## AUTONEUM JSP 14-80

### **AUTONEUM – OFFICE AND RESEARCH & TRAINING BUILDING**

Public Hearing at the request of Dembs Development, Inc. to approve the Preliminary Site Plan and a Stormwater Management Plan for Autoneum. The subject property is located in Section 12, south of Thirteen Mile Road, between Haggerty Road and Cabot Drive. The applicant is proposing to construct a 2-story office/research & development building, consisting of 47,170 square feet of office space, 31,404 square feet of high bay and technical areas and 8,132 square feet of warehouse area.

# PLAN REVIEW CENTER REPORT

**SITE PLAN**

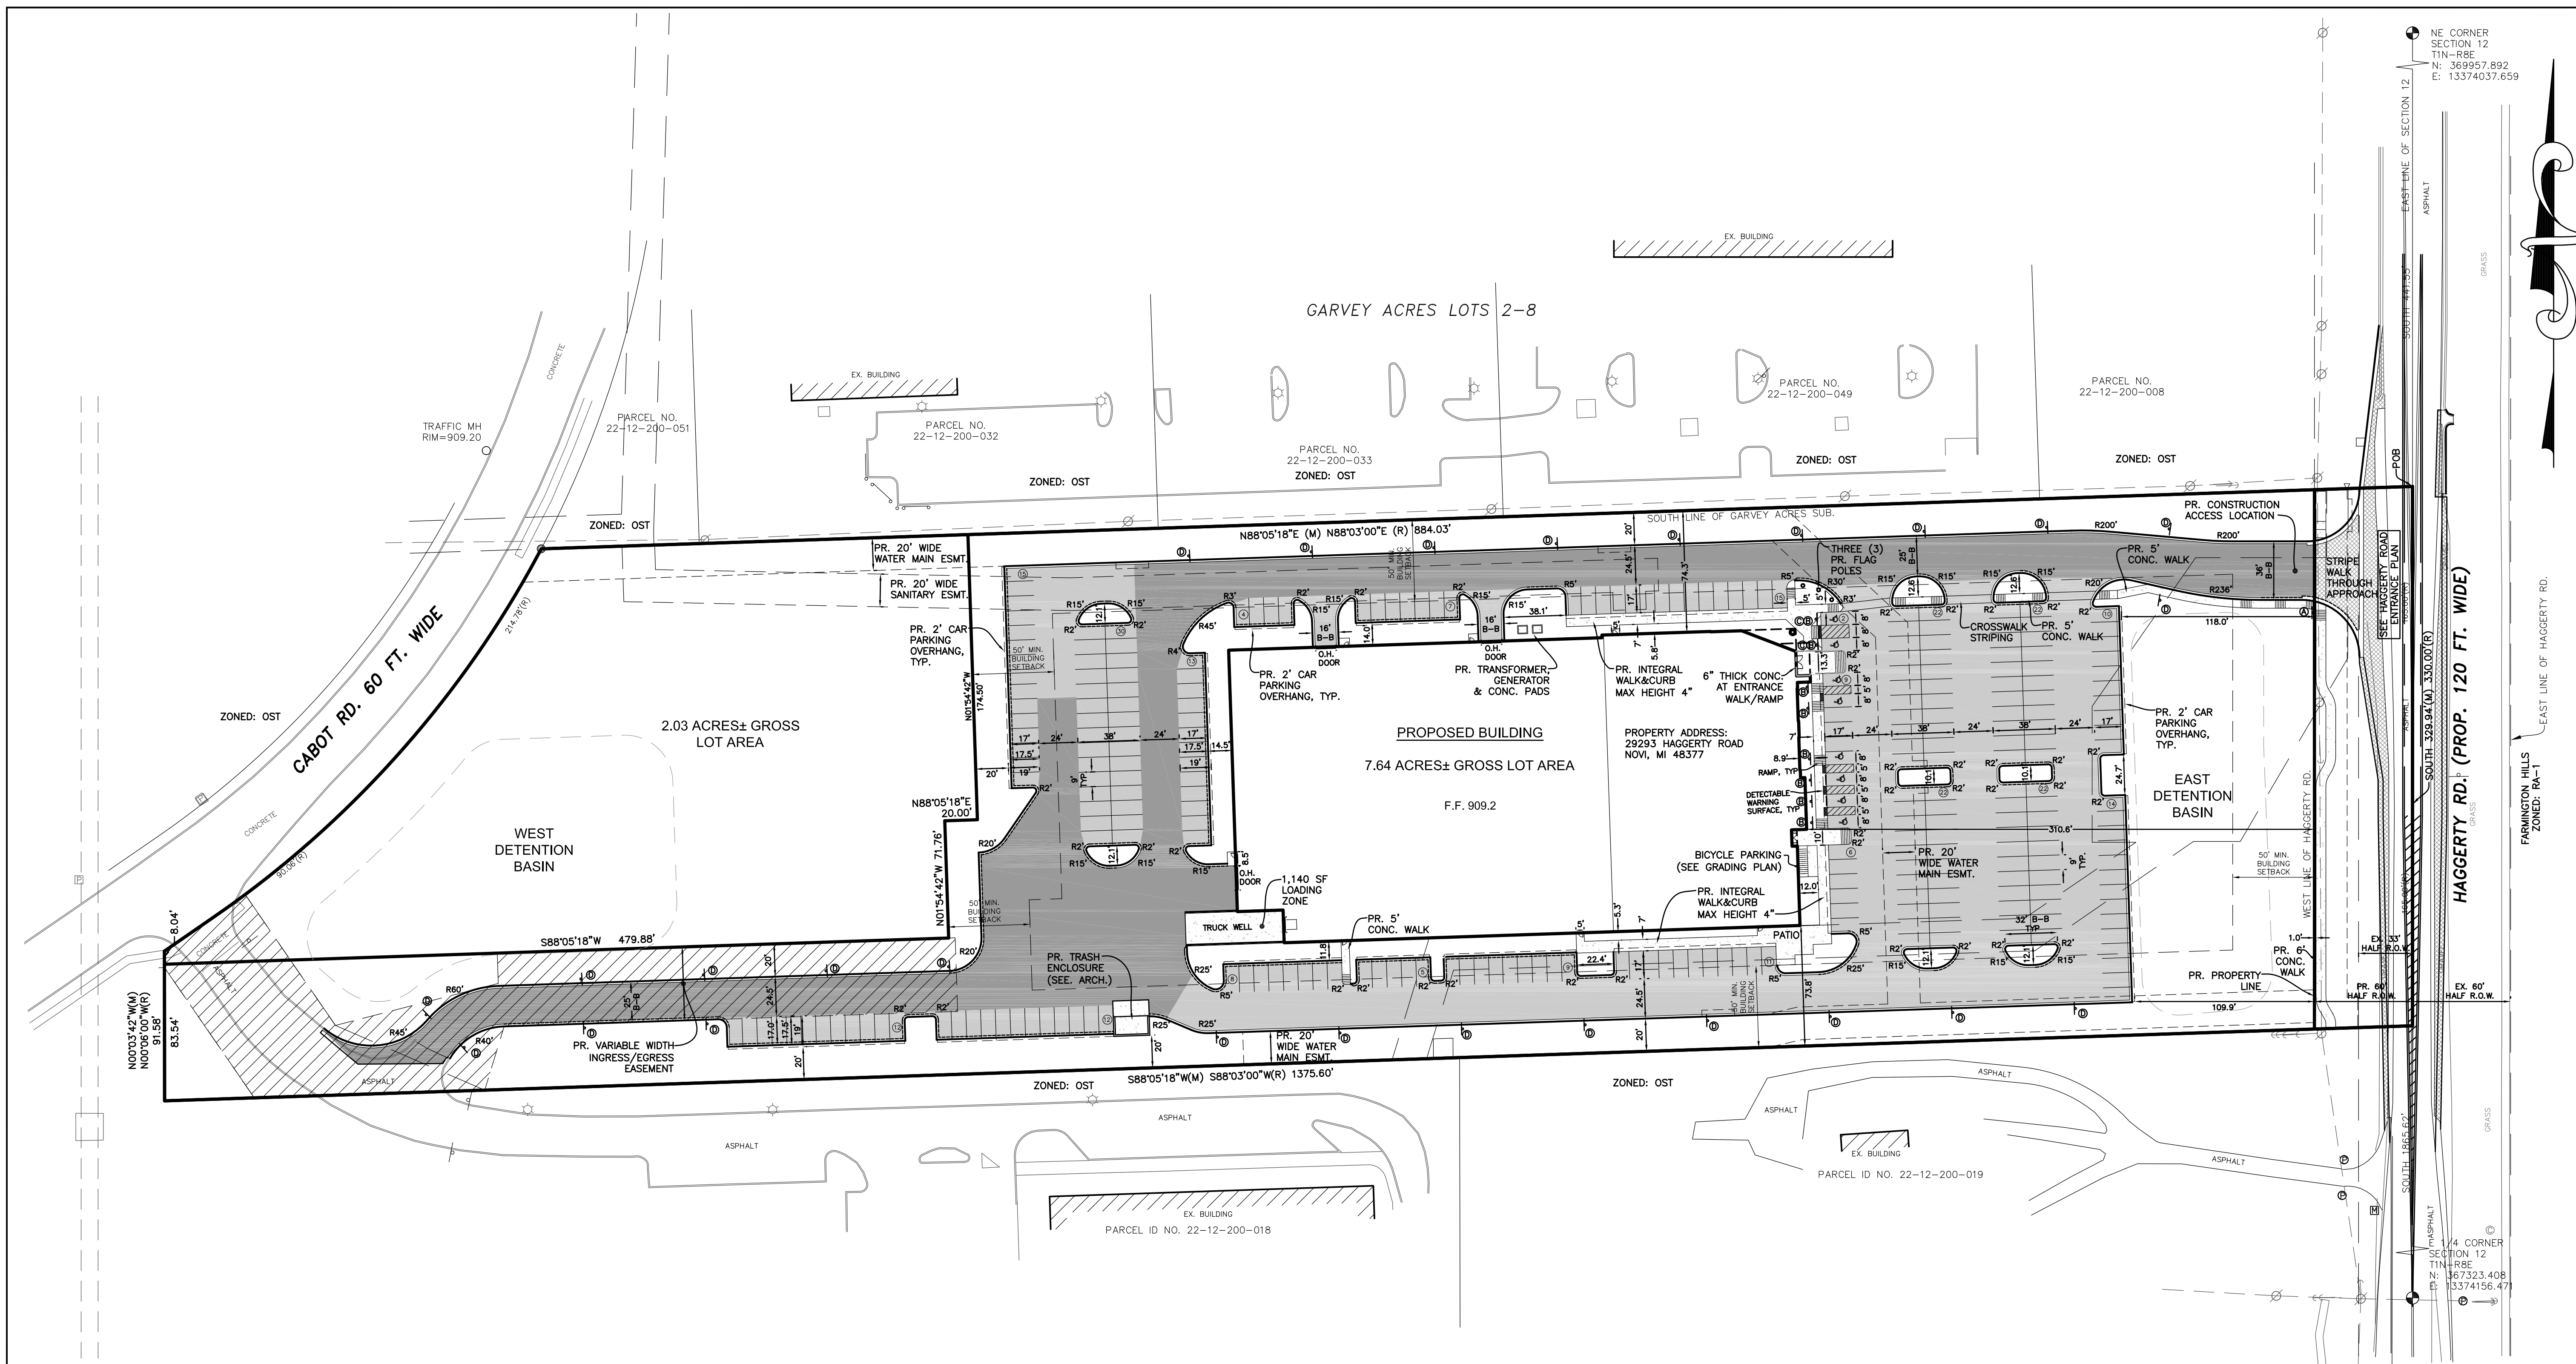
1. Narrative: Although the letter dated December 7, 2015, defines the use of the building as office and research & testing, please provide a brief narrative of the specific operations

3. Required parking calculation (Sec 3.20.2 B and 5.2.12 D). **Please separate the uses within the building into the two distinct areas for office use and industrial/warehouse use. The office use portion should subtract area used for stairways and elevators, while the industrial/warehouse area should subtract area use for storage, hallways and bathrooms. Please list this information on Sheet PFP 10-A or PFP 10-B.**

5. Article XI. Off-Road Non-Motorized Facilities: *A 6 foot sidewalk is required along collector and arterial roads.* **Sidewalk shall be required along Cabot Drive to connect to existing sidewalk network at the time of final site plan review.**

8. Lighting (Sec 5.7):
    - a. **The light poles should be illustrated on the landscape plan so as to not conflict with tree planting.**
    - b. **Light pole operation hours listed as 8 am to 5 pm, which is during daylight hours even in winter.**

1. There are proposed parcel boundaries shown on the proposed plan with portions of the improvements for this site proposed to on a separate parcel in the future. The applicant should clarify the intent of the parcel boundaries and provide easements as required.

2. A right-of-way permit will be required from the City of Novi and Oakland County.
3. A pedestrian pathway is required along the Cabot Dr. frontage.
4. Provide a construction materials table on the Utility Plan listing the quantity and material type for each utility (water, sanitary and storm) being proposed.

5. Provide a utility crossing table indicating that at least 18-inch vertical clearance will be provided, or that additional bedding measures will be utilized at points of conflict where adequate clearance cannot be maintained.

6. Generally, all proposed trees shall remain outside utility easements. Where proposed trees are required within a utility easement, the trees shall maintain a minimum 5-foot horizontal separation distance from any existing or proposed utility. All utilities shall be shown on the landscape plan, or other appropriate sheet, to confirm the separation distance.

7. Show the locations of all light poles on the utility plan and indicate the typical foundation depth for the pole to verify that no conflicts with utilities will occur. Light poles in a utility easement will require a License Agreement.

17. Provide profiles for all storm sewer 12-inches or larger.
18. A minimum cover depth of 3 feet shall be maintained over all storm sewers. Currently, a few pipe sections do not meet this standard. Grades shall be elevated and minimum pipe slopes shall be used to maximize the cover depth. In situations where the minimum cover cannot be achieved, Class V pipe must be used with an absolute minimum cover depth of 2 feet. An explanation shall be provided where the cover depth cannot be provided.

30. An adequate maintenance access route to the basin outlet structure and any other pretreatment structures shall be provided (15 feet wide, maximum slope of 1V:5H, and able to withstand the passage of heavy equipment). Verify the access route does not conflict with proposed landscaping.

31. Provide a 5-foot wide stone bridge allowing direct access to the standpipe from the bank of the basin during high-water conditions (i.e. stone 6-inches above high water elevation). Provide a detail and/or note as necessary.
